ADDENDUM NO. 2

Project Name: Moorhen Marsh Low Energy Aquatic Plant System

Bid Number: 2020030

This addendum is being released to modify bid documents and to answer questions received to date.

SITE GRADING WITH EXISTING TOPOGRAPHY

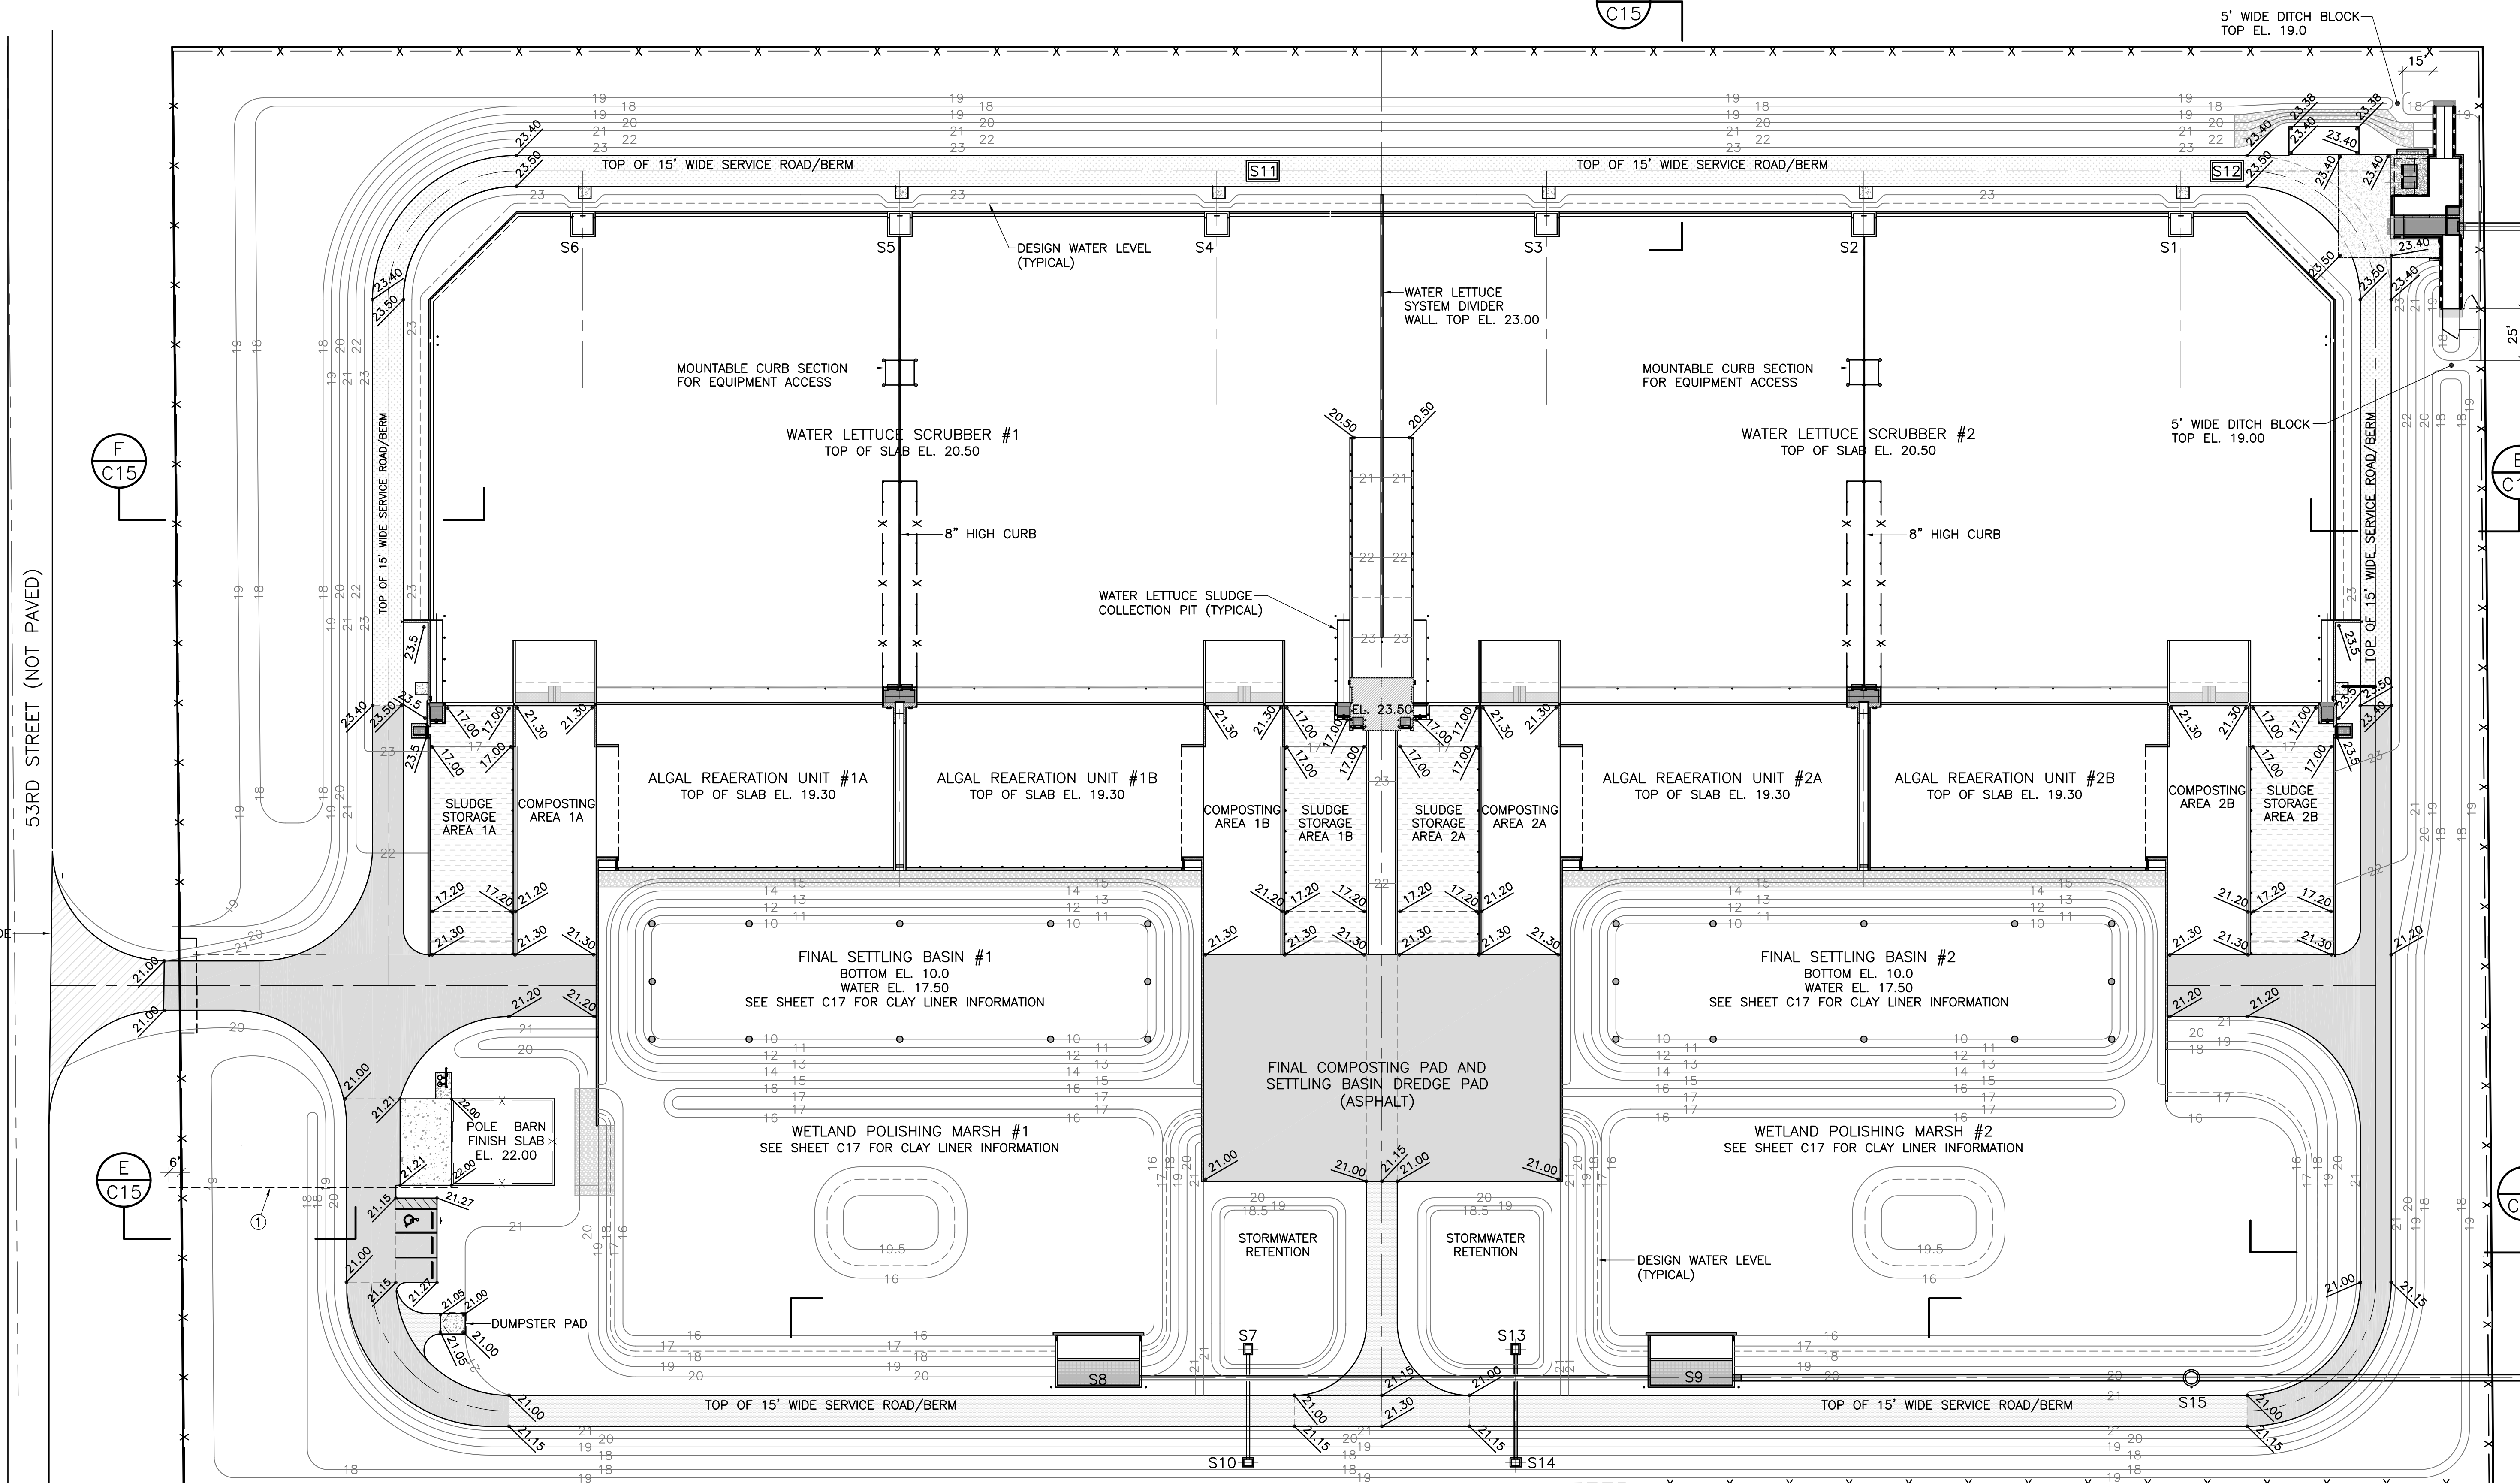
1. 140 LF of empty 2" Sch. 80 PVC electrical conduit has been added from the pole barn to six feet outside 53rd Street right-of-way. Refer to revised Drawings C2a, C2b, and C10, attached. Also attached is revised Section 00310 - Bid Form and Section 01025 – Measurement and Payment, both revised to include the conduit.

① 140' LF OF 2" SCH. 80 PVC ELECTRICAL CONDUIT FOR FUTURE FIBER OPTIC CABLE. CAP SOUTH END AND DRIVE 2"x4" MARKER POST AT END AND PAINT POST RED. BURY CONDUIT 36" TO TOP OF PIPE FROM FINISH GRADE. EXTEND NORTH END AT POLE BARN TO 2' ABOVE GRADE USING LONG SWEEP BENDS AND CAP END. LAY DETECTABLE WARNING TAPE 12" ABOVE TOP OF BURIED CONDUIT. WARNING TAPE TO BE PRINTED "BURIED FIBER OPTIC" OR SIMILAR.

PUMP SYSTEM ONE-LINE

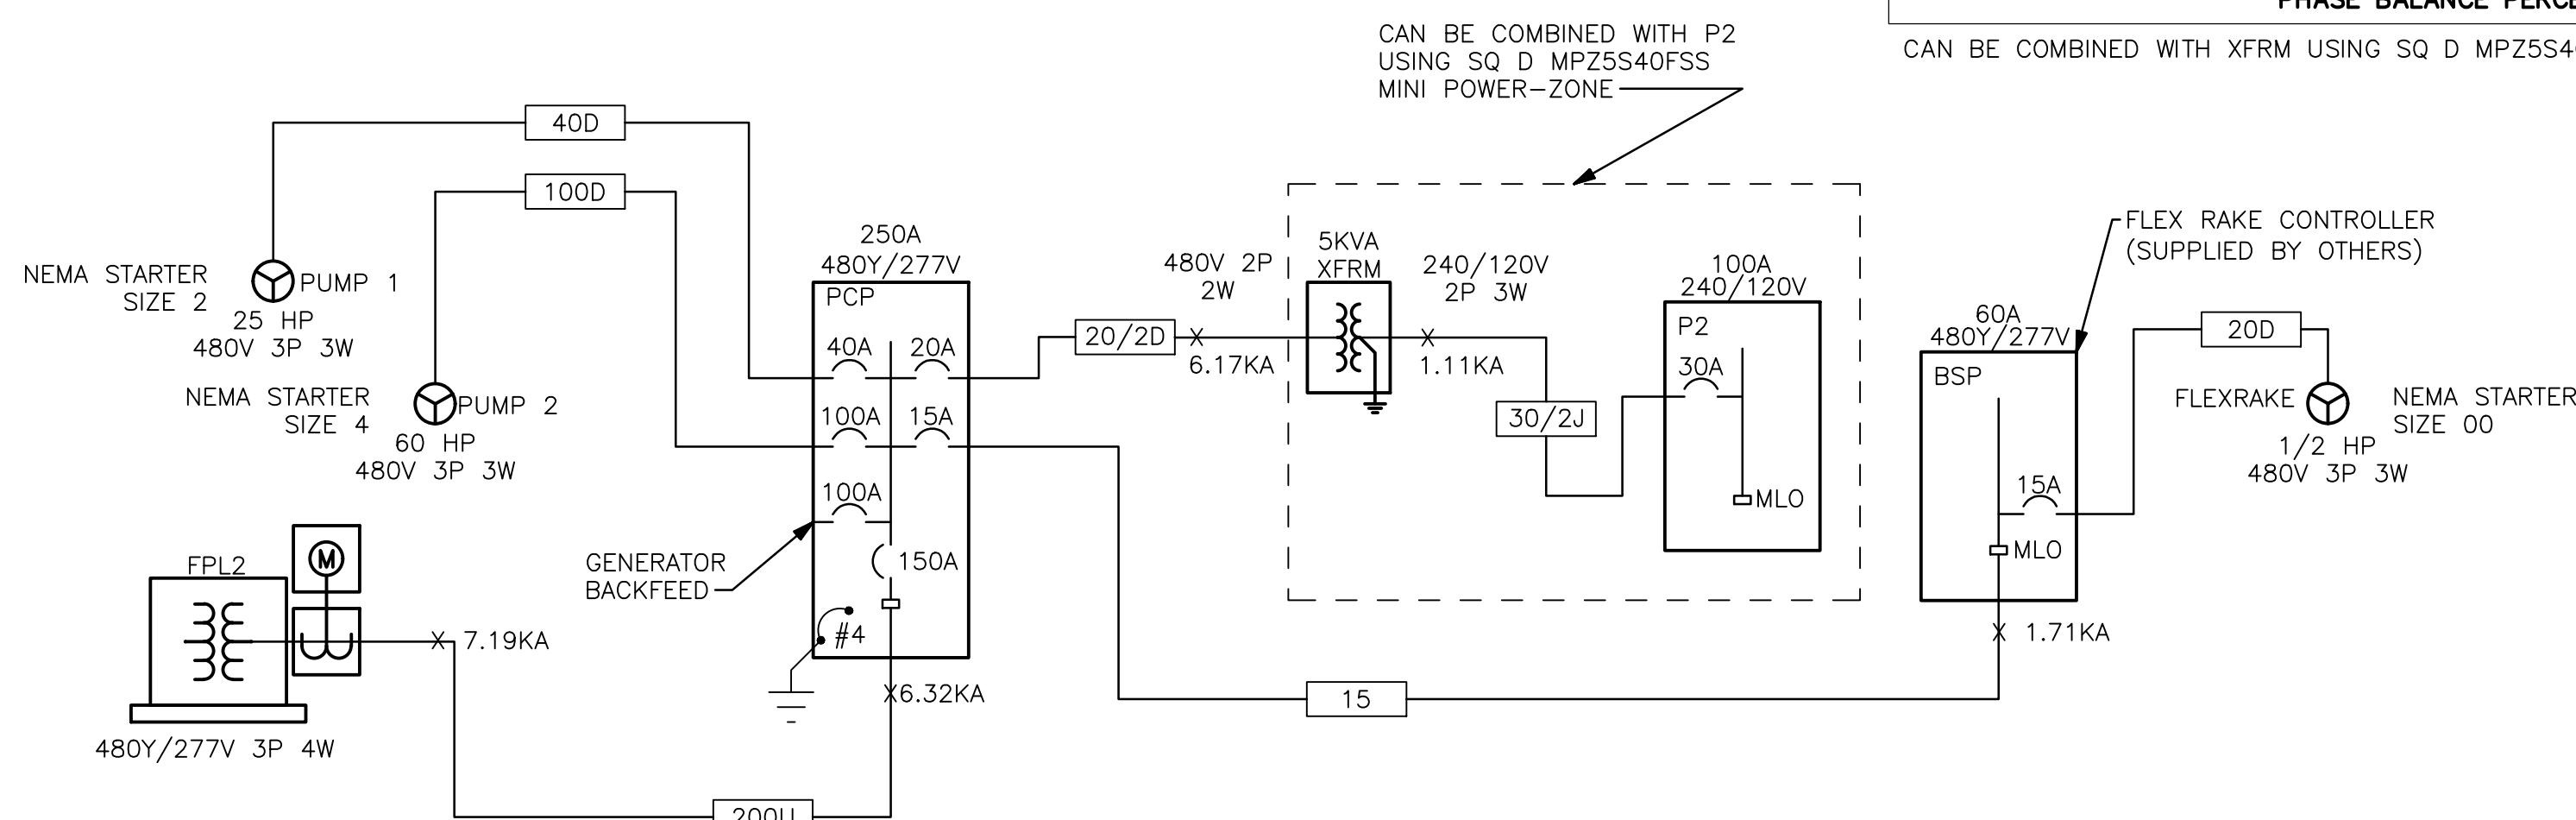
Response: Yes, it will be service rated.
4. In section 2.3 of page 11300-12 the motor starters for the pump control panel are listed as “solid state motor controllers equal to Allen-Bradley Bulletin 150 SMC Plus...” During the design phase, we had discussed the possibility of using VFD motor starters, can you please confirm that VFDs will not be required?

3. The following language has been added to Section 11300 – Submersible Pumps and Appurtenances for Headworks, paragraph 2.4.C: “1. Panel supplier at a minimum shall supply a service rated main breaker control panel that not only supplies the control power and pumps, but also additional distribution for the 5kVA distribution transformer and the rake system per the one-line and panel schedule from the electrical drawings E-4. The main breaker shall also interlock with a 100A generator back-feed breaker. 2. Supply an electrical one-line drawing with ladder logic to be reviewed and approved by the OWNER.” The revised section is attached.

Response: Replace paragraph 2.3.A in its entirety with the following: “The Motor Starters shall be variable speed Motor Controllers equal to Danfoss Aquavar IP20.” Section 11300 has been revised accordingly and is attached.

- C. 1. Panel supplier at a minimum shall supply a service rated main breaker control panel that not only supplies the control power and pumps, but also additional distribution for the 5kVA distribution transformer and the rake system per the one-line and panel schedule from the electrical drawings E-4. The main breaker shall also interlock with a 100A generator back-feed breaker.
- 2. Supply an electrical one-line drawing with ladder logic to be reviewed and approved by the OWNER.
